**UNITED STATES OF AMERICA  
NUCLEAR REGULATORY COMMISSION**

<b>In the Matter of</b>	)	
	)	
<b>U.S. DEPARTMENT OF ENERGY</b>	)	<b>Docket No. 63-001</b>
	)	
<b>(High Level Waste Repository)</b>	)	<b>December 19, 2008</b>

**STATE OF NEVADA'S  
PETITION TO INTERVENE AS A FULL PARTY**

Figure 4.2-2. Annual Frequency of Intersection of Any Feature with the Repository Footprint: Aggregate and Individual Cumulative Probability Results for the 10,000-Year Assessment

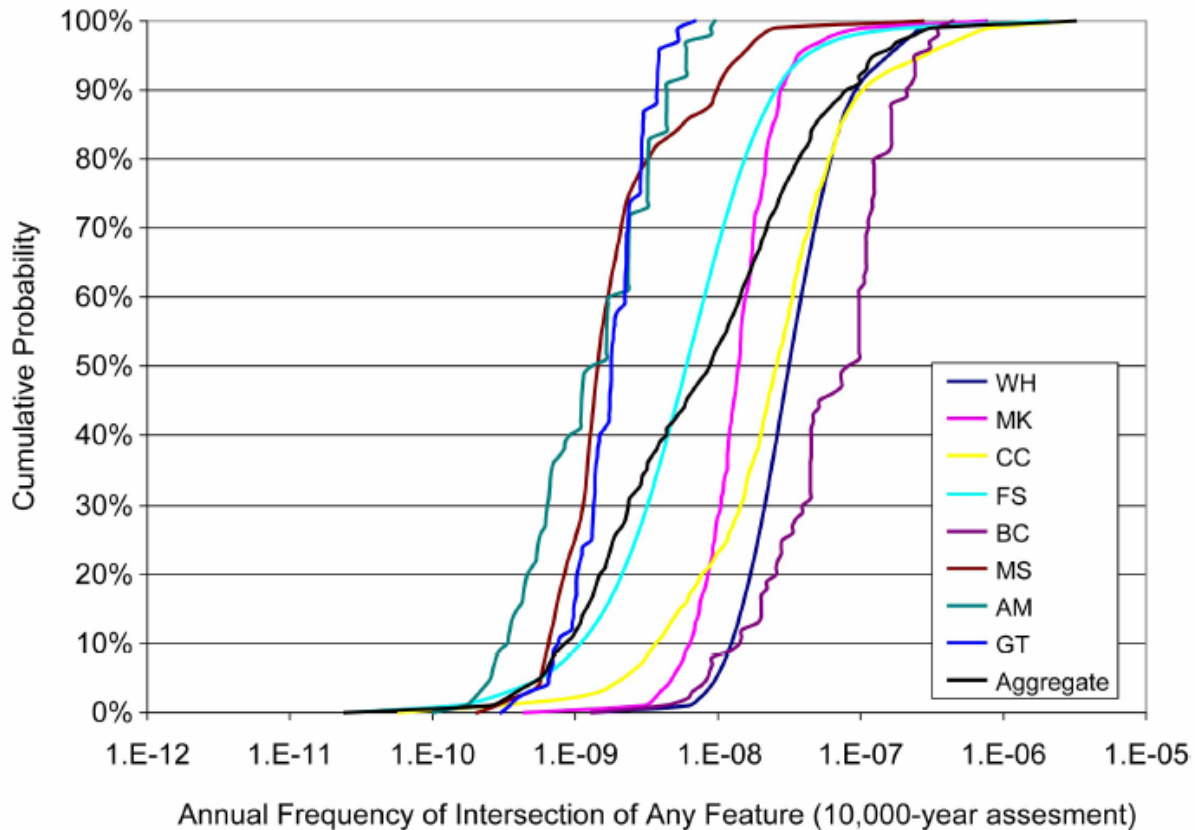
To show that the different methods of aggregation yield different results, an example of application of the three alternative methods is given below. First, the following figure, which is

taken from PVHA-U at 4-115, shows cumulative probability distributions elicited from eight experts along with an aggregate distribution. The latter was calculated, using equal weights for the experts, by averaging vertically, i.e., for each value on the horizontal axis, the values vertically above were averaged. This is "probability averaging," and the resulting aggregate distribution represents the spread of opinion among the eight experts. It is shown by the black line, which cuts across the other eight cumulative distributions, so the variance is larger than any
